No. 14449. CUSTOMS CONVENTION ON CONTAINERS, 1972. CONCLUDED AT GENEVA ON 2 DECEMBER 1972¹

ENTRY INTO FORCE of the amendments to annexes 1, 5, 6 and 7 of the above-mentioned Convention

AMENDMENTS TO THE CUSTOMS CONVENTION ON CONTAINERS, 1972,² WHICH WERE ADOPTED BY THE ADMINISTRATIVE COMMITTEE FOR THE CONVENTION AT ITS SECOND MEETING

SKETCH NO. 6. EXAMPLE OF A SWIVEL RING ("D" RING)

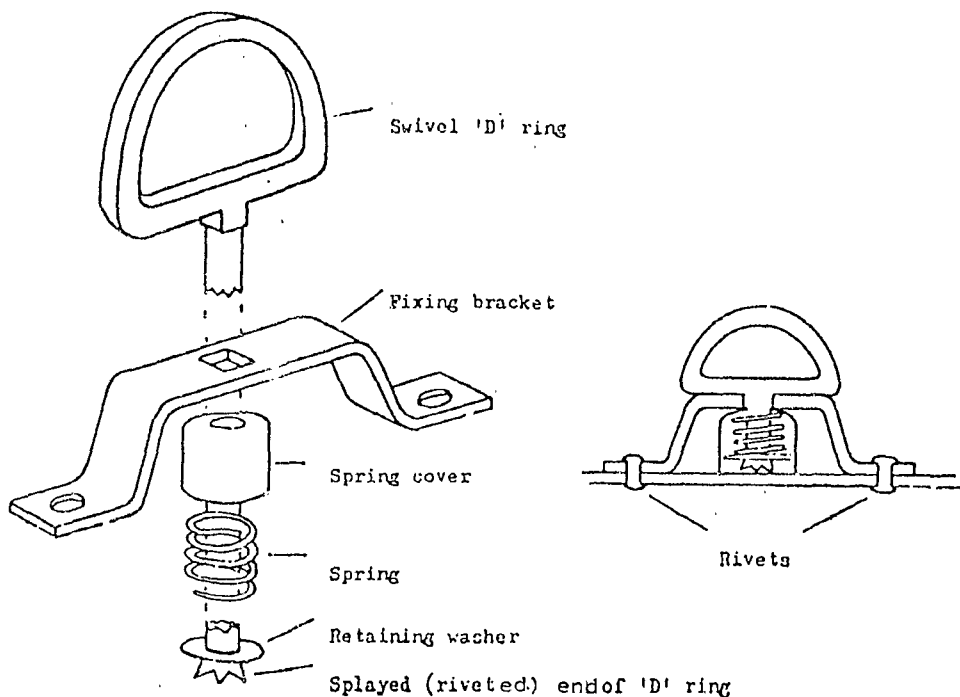
4.4.6. (a) - 3 Metal swivel rings, each of which rotates in a metal bracket fixed to the container are acceptable for the purpose of this paragraph (see sketch No. 6 appended to this Annex) provided that:

- (a) each bracket is affixed to the container in such a manner that it cannot be removed and replaced without leaving obvious traces; and
 - (b) the spring under each bracket is completely enclosed by a bell-shaped metal cover.”
- Insert a new sketch No. 6 reproduced hereunder in Annex 6.
